# YESAB 2013-0132, Whistle Bend Subdivision - Phases 3-7 - an illustrated response

whitehorsewalks.com, Peter Long, January 16, 2014

Page 2 of 12, January 16, 2014; Prepared by whitehorsewalks.com for YESAB 2013-0132. Photos © Peter Long

# Whistle Bend's neighbourhood

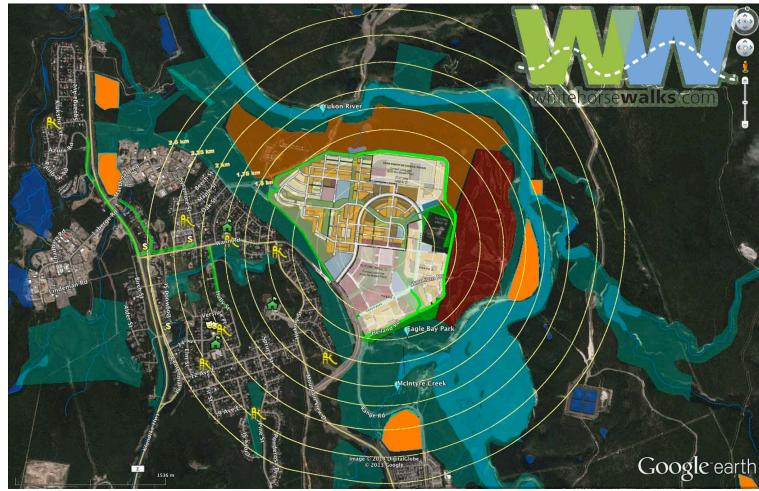
The land beside the river, shown as PE, is often high cliffs, steep banks, sand dunes. The river is about 400 m north of the Whistle Bend subdivision and about 300 m to the south.

Obviously, the off-leash map produced by Bylaw will need updating.

It's important to keep in mind that while YESAB is looking at Phases 3-7, really Phase 1, 2 is part of the pressure on the greenspaces. A big focus for many walkers, and others, will be getting to the river.

# East side of Whistle Bend, the golf course

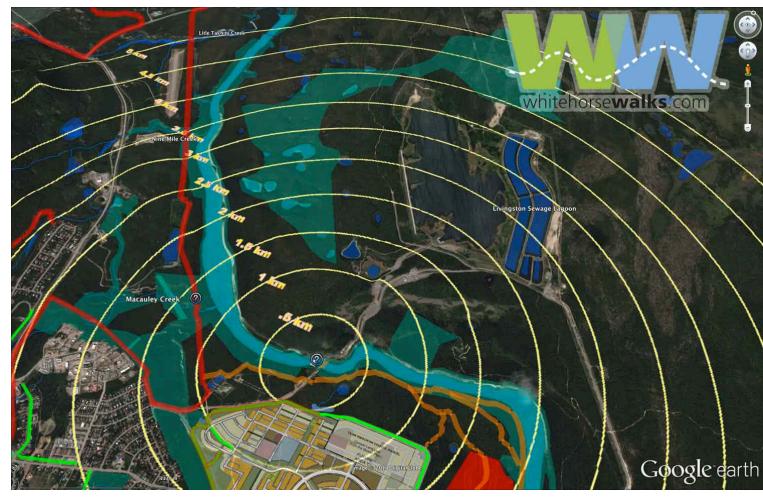
There needs to be larger discussions with the golf club on how the thousands of people living here are to interact with the space and how the Yukon River Corridor Trail would either pass through the course or along the edge.

High fences and restricting walkers to just using the paved Perimeter Trail would be unsightly and not very neighborly.

The orange routes above are suggestions, often following existing trails. Concentric circles spaced every .25 km (250 m).

When looking at trails with the golf course, keep in mind that the trail along the cliffs on the south edge of the golf course is heavily used, very fragile and really pretty. It's a raven playground on a windy day.
